# Access Compliance Report

## Public Rights-of-Way

Intersection ID: N/A	Main Street: STATESVILLE_AV	Cross Street: BADGER_CT	Location: SW
ADA ID: F0DB4509827E	Ramp Type: Combination2Diag	Initial Pass/Fail: Fail	Overall Compliance: No
Severity Score: 0			
Codes/Mitigation Info/Possible Solution		Field Measurements/Component Compliance

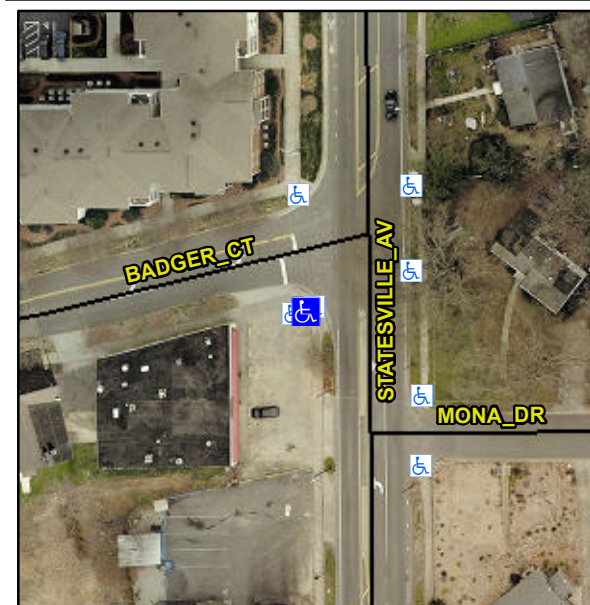
**Not Found, R304.5.1, R304.5.3**

Compliance	Description	Data	Compliance	Description	Data
N/A	Ramp Length LT (in)	42.0	N/A	Ramp Length RT (in)	40.0
Yes	Ramp Width LT (in)	48.0	Yes	Ramp Width RT (in)	48.0
Yes	Ramp Slope LT (%)	6.1	Yes	Ramp Slope RT (%)	2.3
Yes	Ramp XSlope LT (%)	1.1	Yes	Ramp XSlope RT (%)	0.6
N/A	Ramp Length (in)	25.0	Yes	Ramp Slope (%)	6.3
No	Ramp Width (in)	47.5	No	Ramp XSlope (%)	4.6
N/A	Flare Type LT	N/A	N/A	Flare Type RT	N/A
N/A	Flare Slope LT (%)	N/A	N/A	Flare Slope RT (%)	N/A
N/A	Flare Traversable LT?	N/A	N/A	Flare Traversable RT?	N/A
N/A	Landing Length (in)	N/A	N/A	DWS Provided?	N/A
N/A	Landing Width (in)	N/A	N/A	DWS Contrast?	N/A
N/A	Landing Slope (%)	N/A	N/A	DWS Length (in)	N/A
N/A	Landing X Slope (%)	N/A	N/A	DWS Full Width?	N/A
N/A	Landing Curb? (Y/N)	N/A	N/A	DWS Offset (in)	N/A
N/A	Shared Landing?	N/A			
N/A	Gutter Ponding?	N/A	N/A	Gutter Slope (%)	N/A
N/A	Gutter Lip Ht (in)	N/A	N/A	Gutter X Slope (%)	N/A
N/A	Painted X Walk1?	No	N/A	Painted X Walk2?	No

X Walk 1 Direction	To E		X Walk 2 Direction	To N
	X Walk 1 Width (in)	N/A		X Walk 2 Width (in)	N/A
	X Walk 1 Slope (%)	6.0		X Walk 2 Slope (%)	1.8
	X Walk 1 X Slope (%)	0.5		X Walk 2 X Slope (%)	5.0
N/A	Ramp inside XWalk1?	N/A	N/A	Ramp inside XWalk2?	N/A
	Road Slope (%)	3.6		Clear Space?	N/A
	Road X Slope (%)	3.8	N/A	Clear Space to XWalk (in)	N/A
			N/A	Any Obstruction?	N/A
				Obstruction Type	N/A
			N/A	Storm Grate/Utility Hazard?	N/A
				Storm Grate/Utility Type	N/A
Yes	Surface Condition? (G/P)	Good			
	Curb Slope (%)	22.9

**Remove & Replace Curb Ramp With Two New Directional Ramps or Equivalent.**
